Access Compliance Report

Public Rights-of-Way

Intersection ID: 5236	Main Street: COPPALA_DR	Cross Street: KORNIV_DR	Location:	SW
ADA ID: 00B1469F3DCB	Ramp Type: PerpDiag	Initial Pass/Fail: Fail	Overall Compliance: No	Severity Score: 25
Codes/Mitigation Info/Possible Solution		Field Measurements/Component Compliance

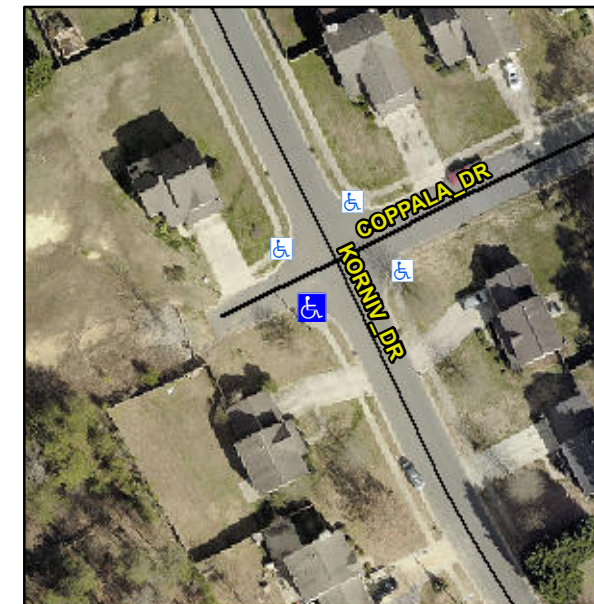
R304.2.2

Compliance	Description	Data	Compliance	Description	Data
N/A	Ramp Length (in)	47.0	No	Ramp Slope (%)	12.5
Yes	Ramp Width (in)	70.0	Yes	Ramp XSlope (%)	1.5
N/A	Flare Type LT	N/A	N/A	Flare Type RT	N/A
N/A	Flare Slope LT (%)	N/A	N/A	Flare Slope RT (%)	N/A
N/A	Flare Traversable LT?	N/A	N/A	Flare Traversable RT?	N/A
N/A	Landing Length (in)	N/A	N/A	DWS Provided?	N/A
N/A	Landing Width (in)	N/A	N/A	DWS Contrast?	N/A
N/A	Landing Slope (%)	N/A	N/A	DWS Length (in)	N/A
N/A	Landing X Slope (%)	N/A	N/A	DWS Full Width?	N/A
N/A	Landing Curb? (Y/N)	N/A	N/A	DWS Offset (in)	N/A
N/A	Shared Landing?	N/A			
N/A	Gutter Ponding?	N/A	N/A	Gutter Slope (%)	N/A
N/A	Gutter Lip Ht (in)	N/A	N/A	Gutter X Slope (%)	N/A
N/A	Painted X Walk1?	No	N/A	Painted X Walk2?	No
	X Walk 1 Direction	To E		X Walk 2 Direction	To N
N/A	X Walk 1 Width (in)	N/A	N/A	X Walk 2 Width (in)	N/A
	X Walk 1 Slope (%)	1.0		X Walk 2 Slope (%)	1.4
	X Walk 1 X Slope (%)	4.1		X Walk 2 X Slope (%)	0.2

Remove & Replace Curb Ramp With Two New Directional Ramps or Equivalent.
